LARAMIE COUNTY PLANNING & DEVELOPMENT DEPARTMENT

MEMORANDUM

TITLE: Review and action of a Subdivision Permit and Plat for Pronghorn Bluff, 1st

Filing, located in Tract 5, Sells Addition, Laramie County, WY.

existing CONDITIONS MAP FOR PRONGHORN BLUFF

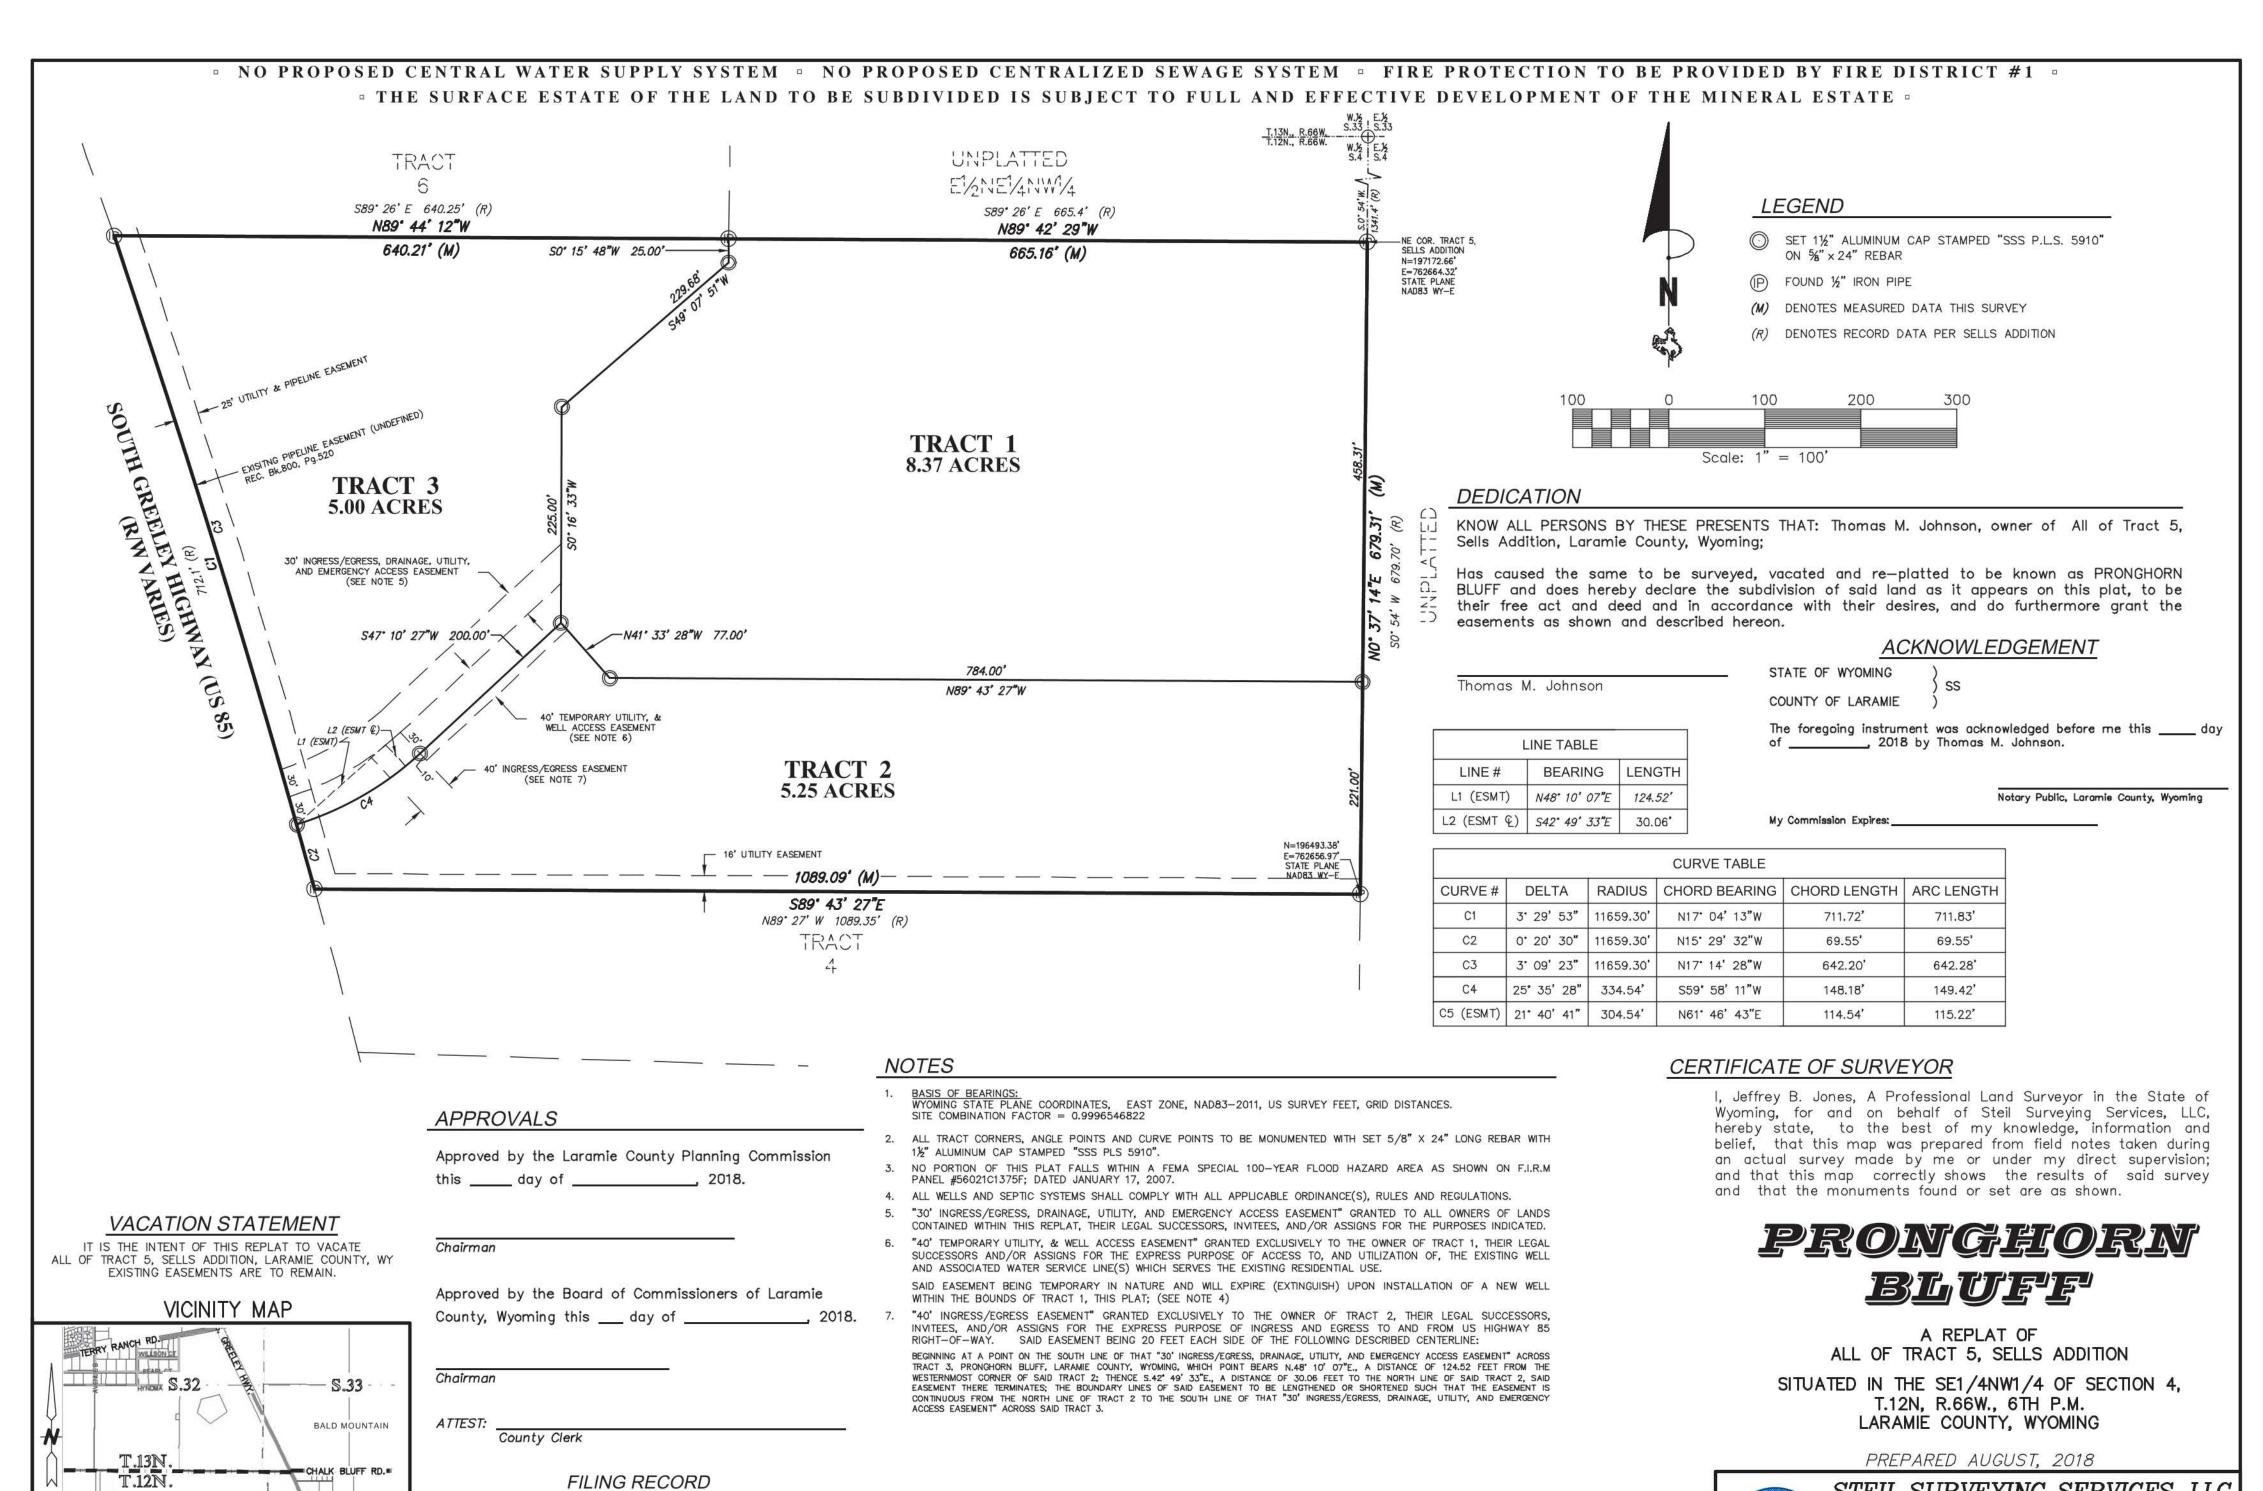
- 1. On Note 6 in the second paragraph it refers to "Lot 1" and it should say "Tract 1".
- 2. On Note 7 in the second paragraph it says "...such theat the easement..." and it should say "...such that the easement...".

- 3. On Note 8 in the second paragraph is says "Beginning a point..." and it should say "Beginning at a point...".
- 4. Also on Note 8 in the second paragraph it says "...such theat the easement..." and it should say "...such that the easement...".

- 1. There is no survey tie to the nearest public land survey system monument. The east boundary of the subdivision appears to be near or on the north-south centerline of the section, but it is not labeled as such and no PLSS monument tie is shown.

- 2. The Vicinity Map would be easier to read and it would be more useful to the 'lay public' if one were to add some information such as, at a minimum, the Section, Township and Range data with enough detail to indicate the location of the subdivision within the Section. There is a 38 above the site, should that be a 33?

- 3. With respect to the legend, the FOUND IRON PIPE symbol is difficult to identify on the plat.
- 4. The ACKNOWLEDGEMENT for Thomas M. Johnson would be more appropriately placed directly under the DEDICATION, that which he is actually acknowledging.

- 1. Applicant is required to meet all applicable requirements per Section 2-1-1-1 (e)(i-xiv).
- 2. The Fire District providing fire protection is stated as FD #2, this needs to be corrected to FD #1.
- 3. A Wyoming P.L.S. Stamp needs to be included on the plat.
